Inver Grove Heights Planning Commission
Tuesday, June 4, 2024 at 7:00 PM
8150 Barbara Avenue, Inver Grove Heights, MN 55077

AGENDA

MEETING DATE:	June 4, 2024
CASE NO:	24-15V
APPLICANT:	Toll Company
PROPERTY OWNER:	Stag Industrial Holdings, LLC
REQUEST:	Variance
LOCATION:	8450 Courthouse Boulevard
COMPREHENSIVE PLAN:	Industrial Office Park
ZONING:	IOP, Industrial Office Park
STAFF CONTACT:	Allan Hunting, 651.450.2554

MEETING DATE:	June 4, 2024
CASE NO:	24-16PUD
APPLICANT:	InSite Development Services, LLC
PROPERTY OWNER:	Graceland IGH Holdings, LLC
REQUEST:	Planned Unit Development Amendment
LOCATION:	7761 Amana Trail
COMPREHENSIVE PLAN:	RC, Regional Commercial
ZONING:	PUD, Planned Unit Development
STAFF CONTACT:	Allan Hunting, 651.450.2554

TOLL			
TITLE:	BULK STORAGE FACILITY, PLAN & ELEVATION VIEW SIMPSON STRONG TIE, INC. WINTER 2023		
COMPANY:	Toll Company	CREATOR:	Thomas Litzkow
PREPARED FOR:	Kyle Mueller	DATE:	Dec 6 th 2023

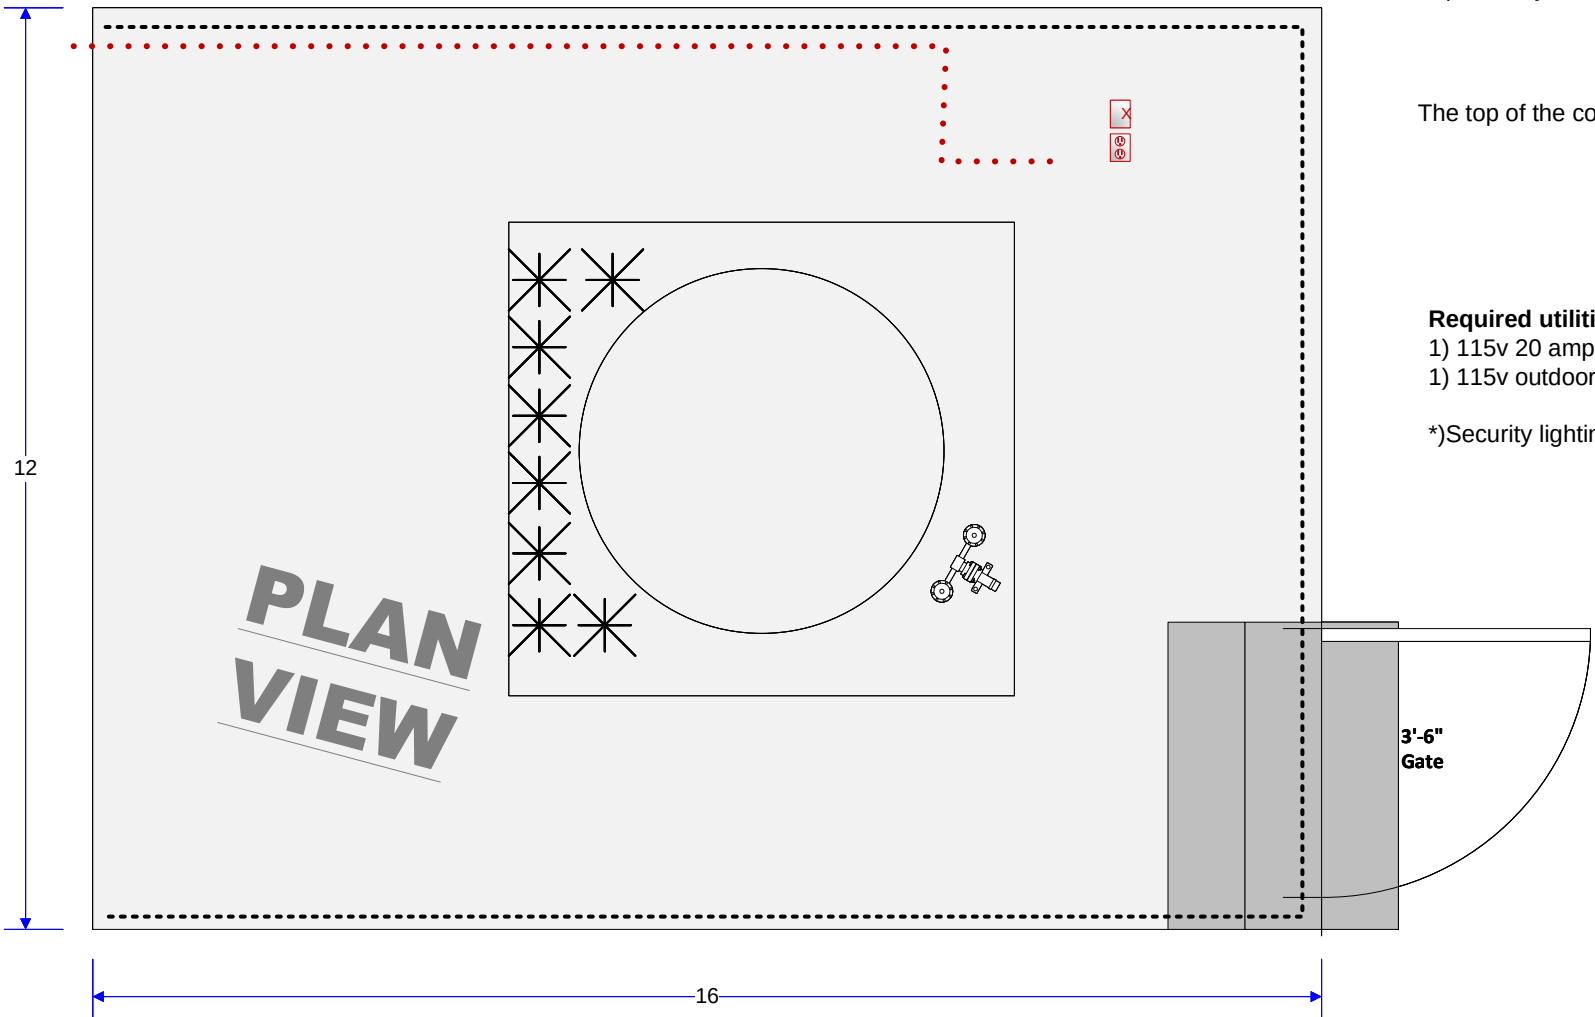
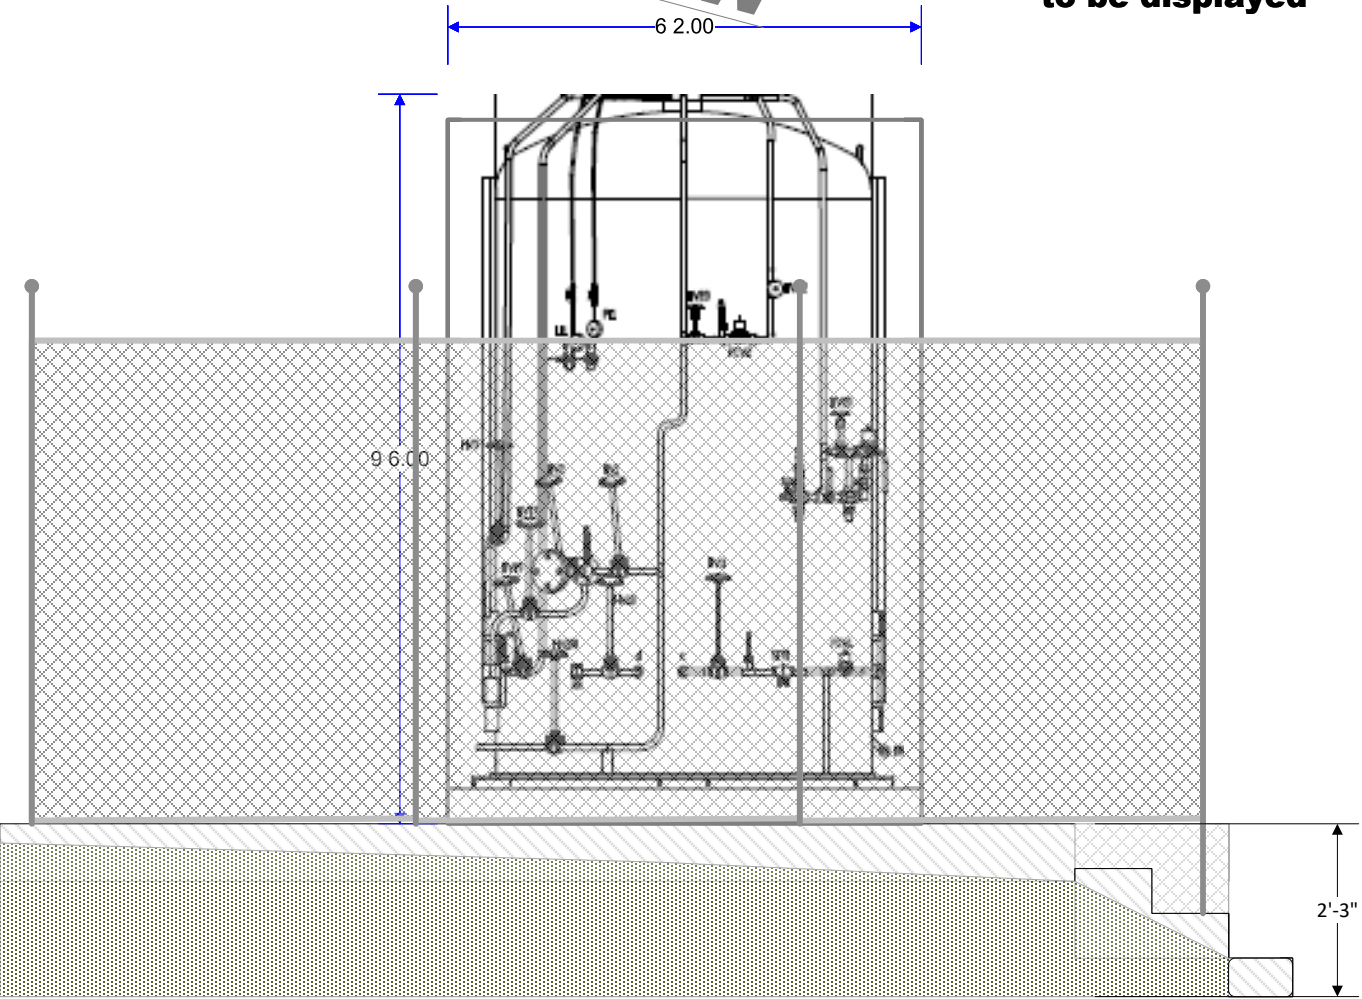
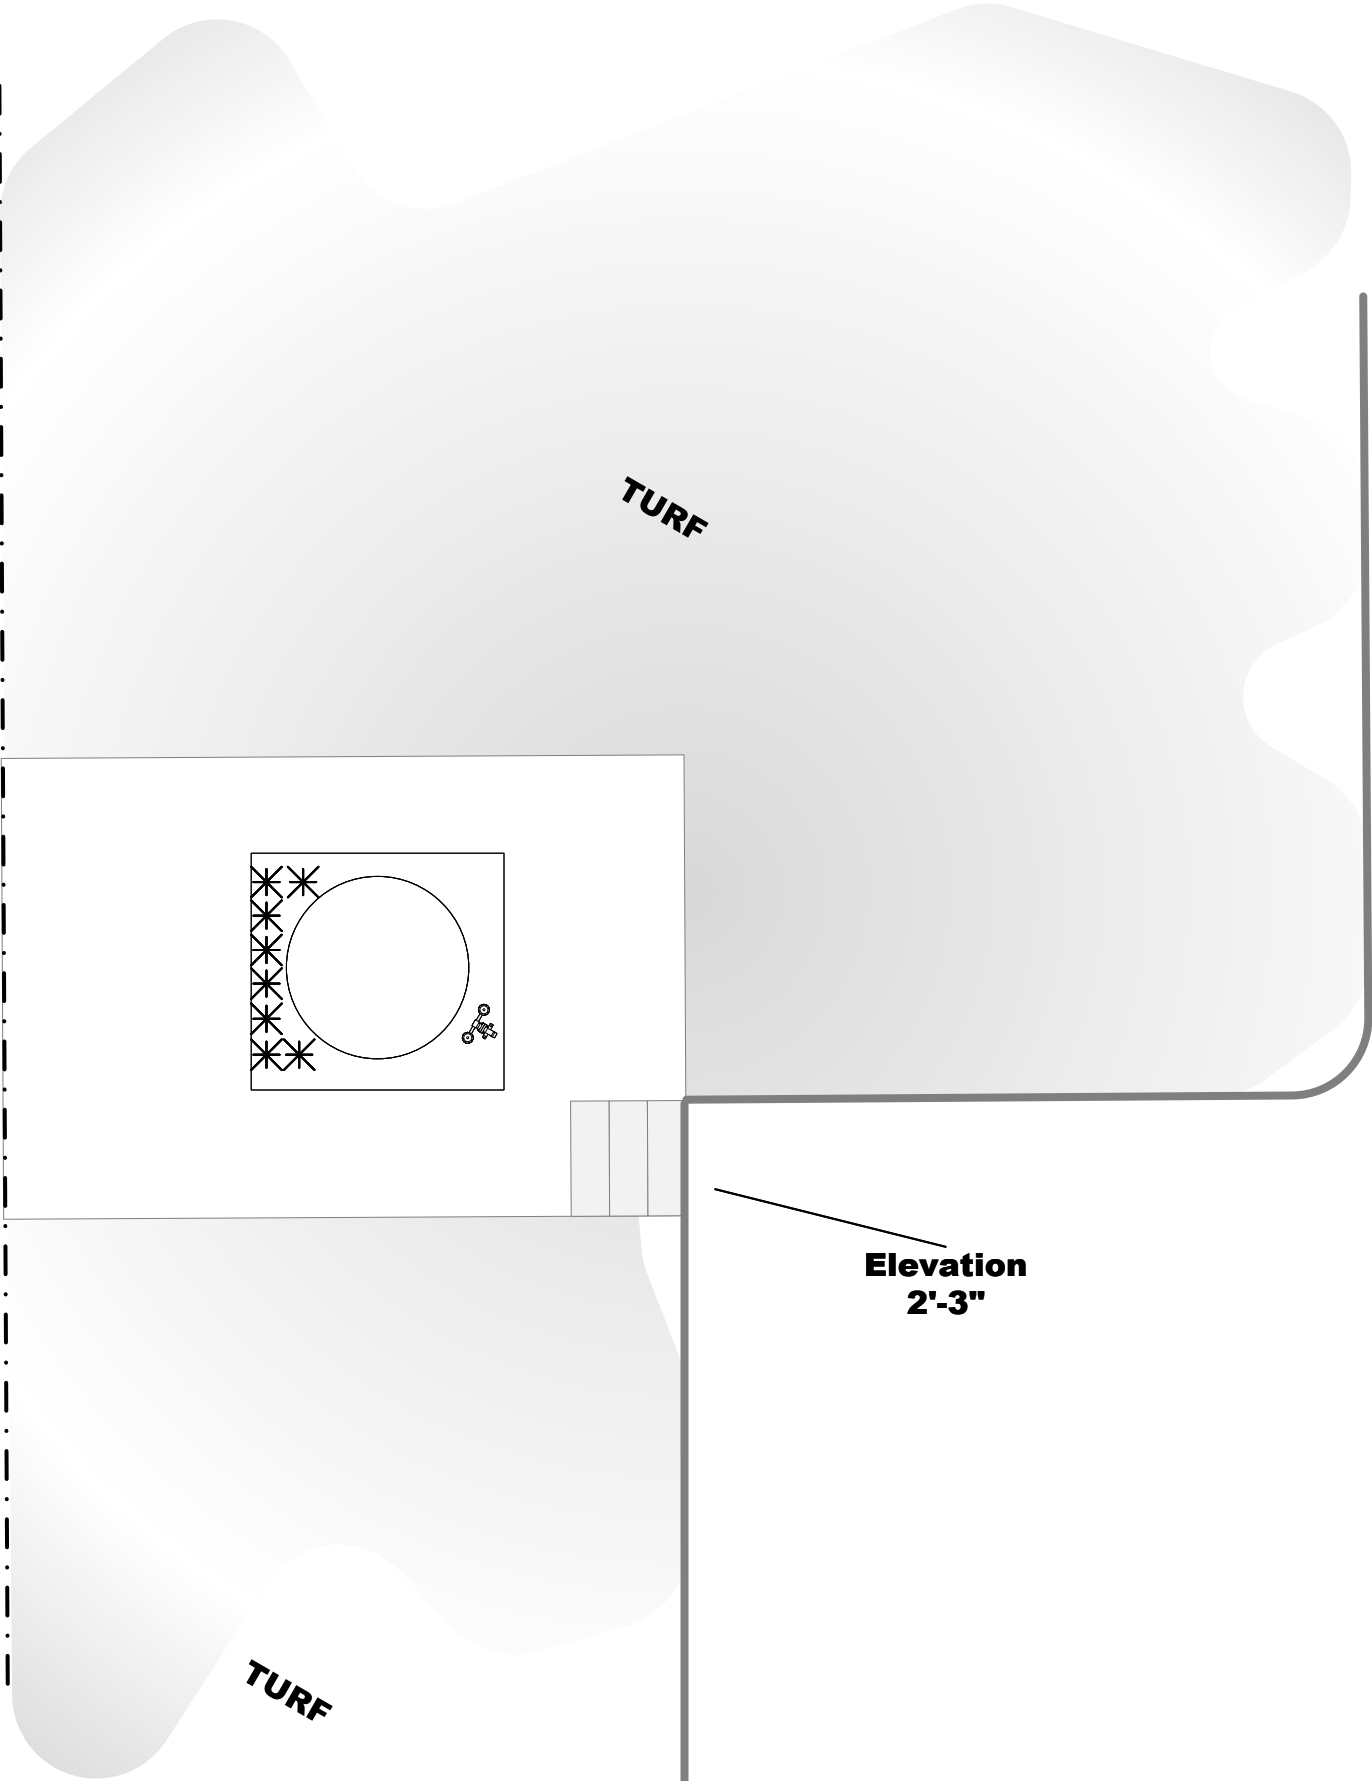
a) The use of the tank is associated with an existing tenant of the most eastern building in the industrial park. The tank and slab it would be constructed on is located adjacent to the building next to the parking lot. The outdoor storage is not located in the parking lot or does not take up any other open space or create a highly visible distraction. The use of the tank is consistent with an allowed use in that district. The only difference is the tank is outside the building.

The proposed location of the tank appears to be in a reasonable location that does not conflict with the intent of the outdoor storage restriction. The tank is located next to the building in a green space between the building and the parking lot.

The reason to locate the tank outside appears to be one of safety, since a nitrogen leak inside a building does displace oxygen which would create an unsafe condition for the occupants of the building.

- Approval of the **Variance** to allow outdoor storage of a nitrogen tank subject to the following condition:

1. The plans shall be in substantial conformance with the following plans on file with the Planning Department except as may be modified by the conditions below.

Plan & Elevation View dated 5/21/2024

SITE PLAN

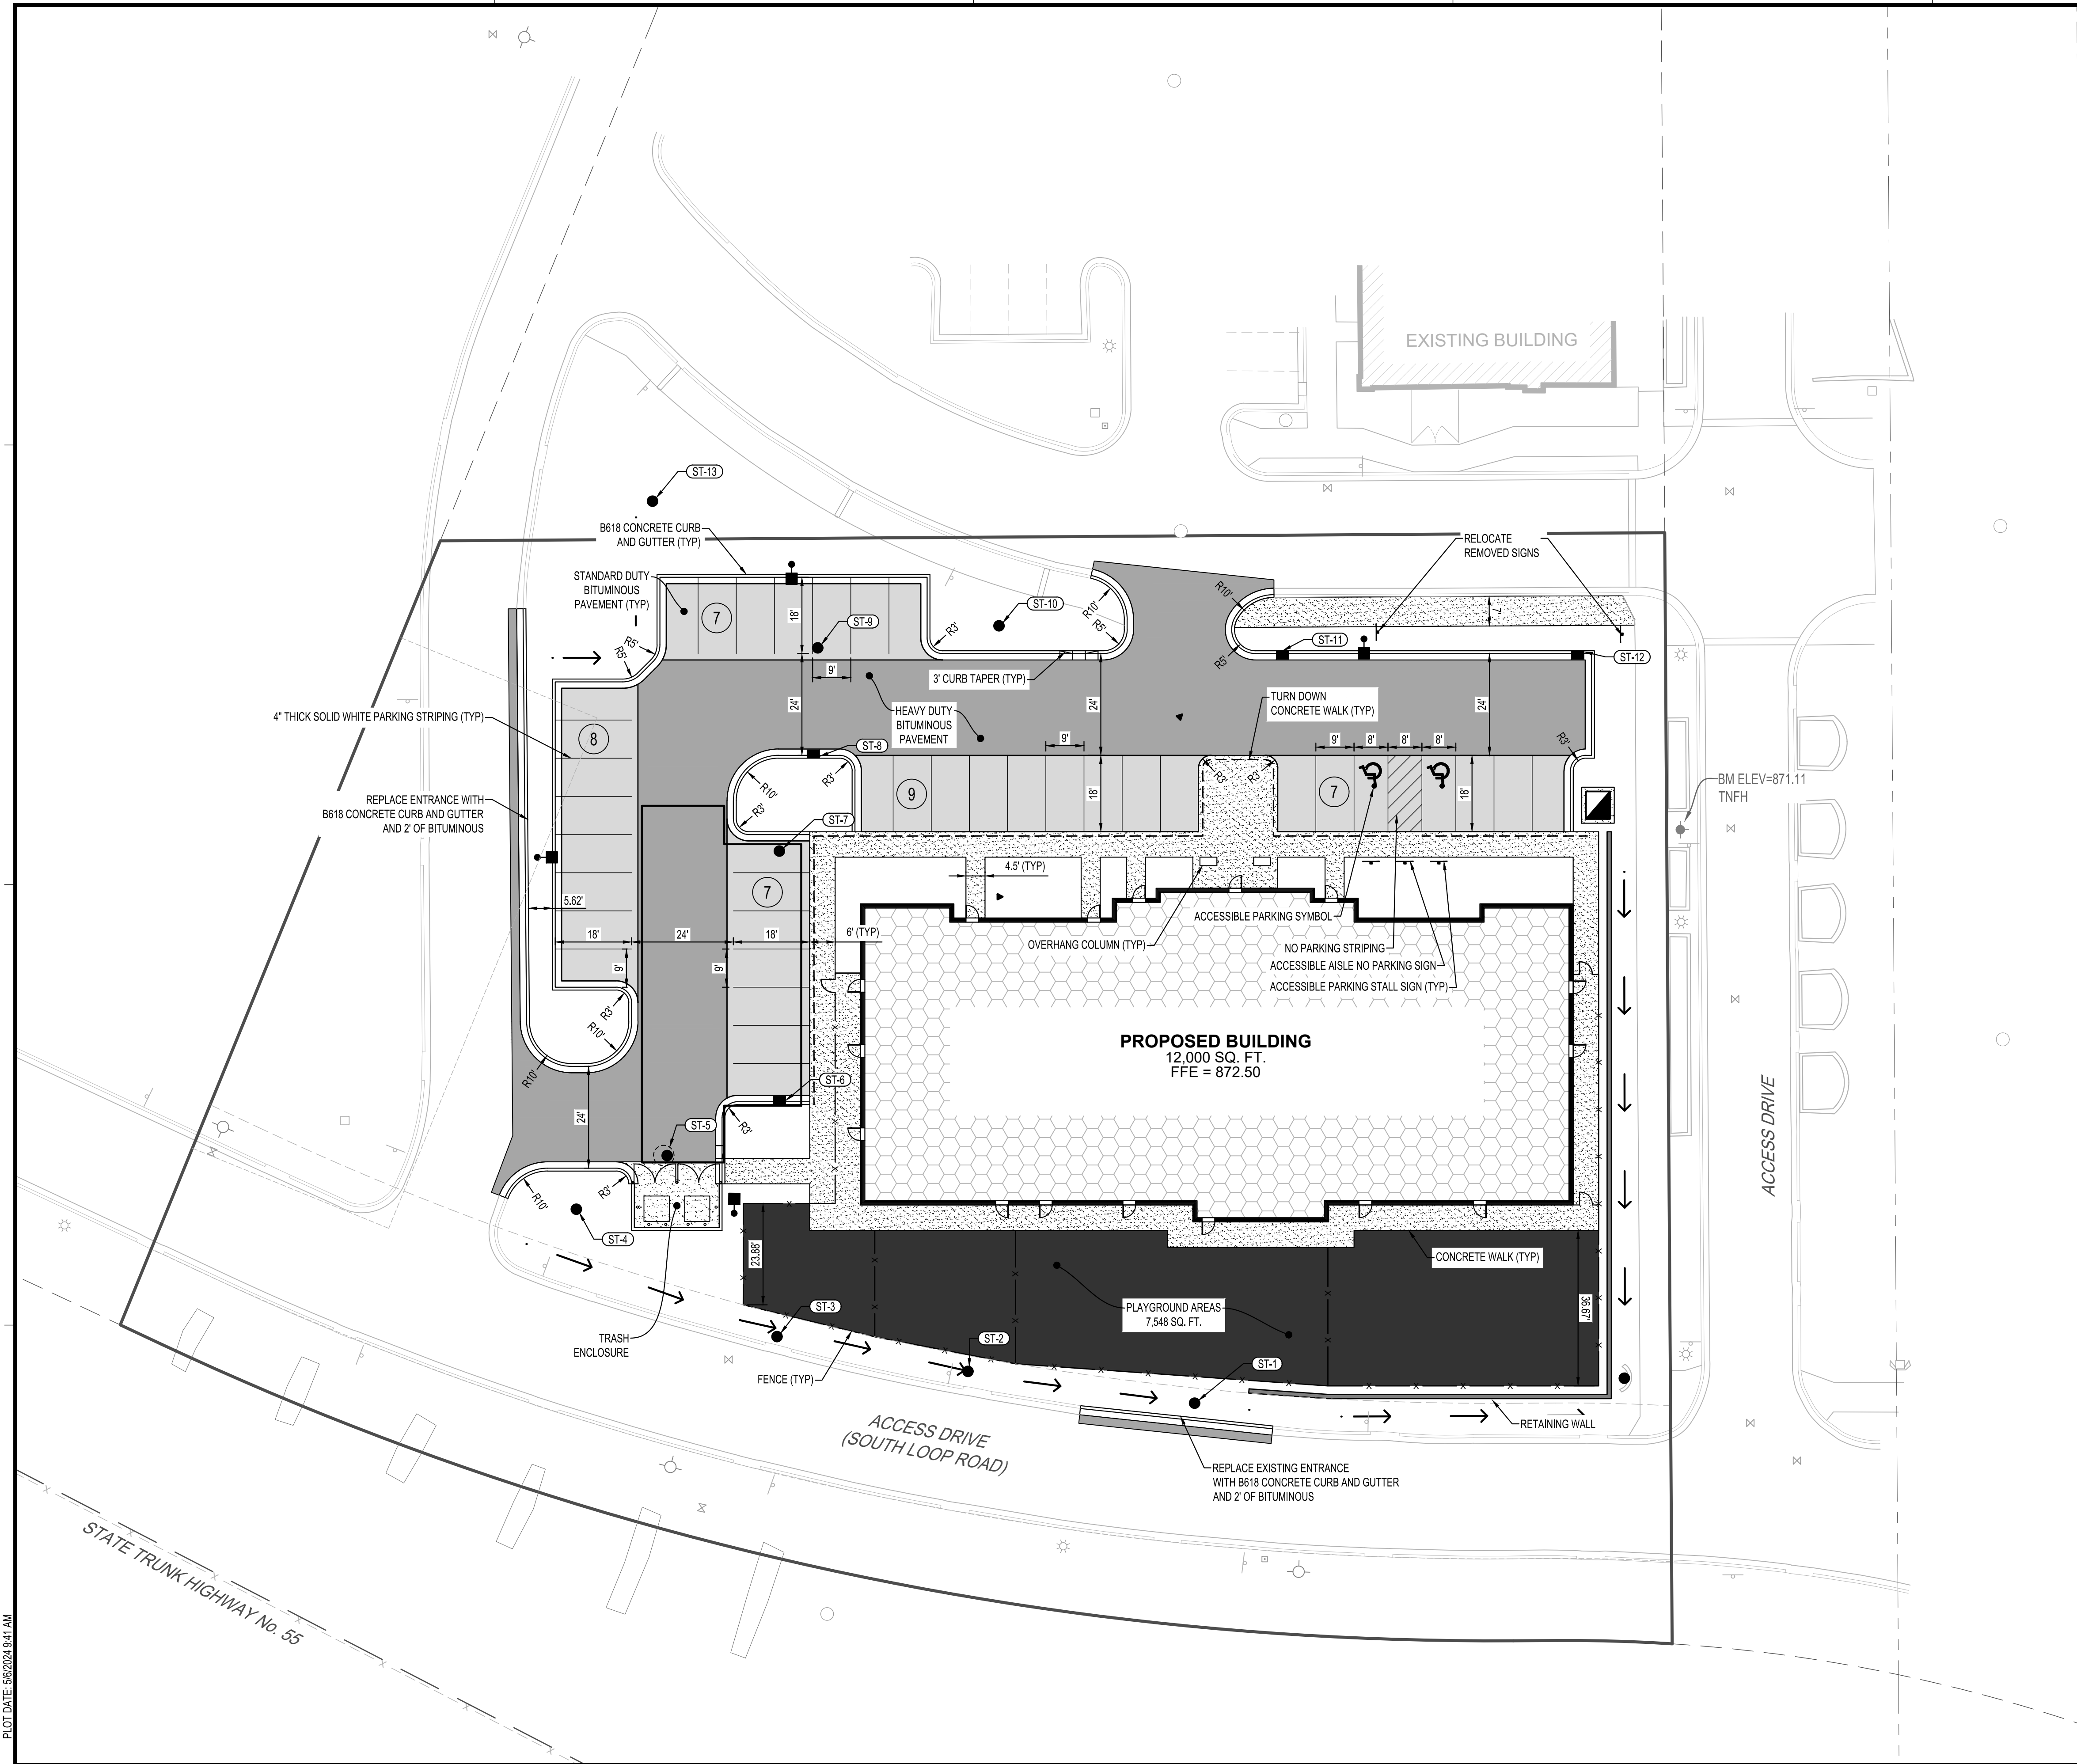
Setbacks. The proposed building setback along the main street access drive is consistent with the original approval with the building placed closer to the drive. There are no required internal setbacks for a PUD.

Parking. Based on parking standards identified in the code and in the Northwest Area, the minimum parking spaces required for staff and students would be 35 spaces. The site plan shows a total of 38 spaces. The proposed site plan complies with parking requirements.

along the north and west sides. Parking on the west side is intended for employee parking and drop-off and parent parking would be located at the front of the building.

Access continues to utilize the internal access system, so there is one access to the southerly ring road and to the internal driveway that connects to the main street access drive.

1. The Final Plat and accompanying site plans shall be in substantial conformance with the following plans on file with the Planning Department except as may be modified by the conditions below.

Site Plan
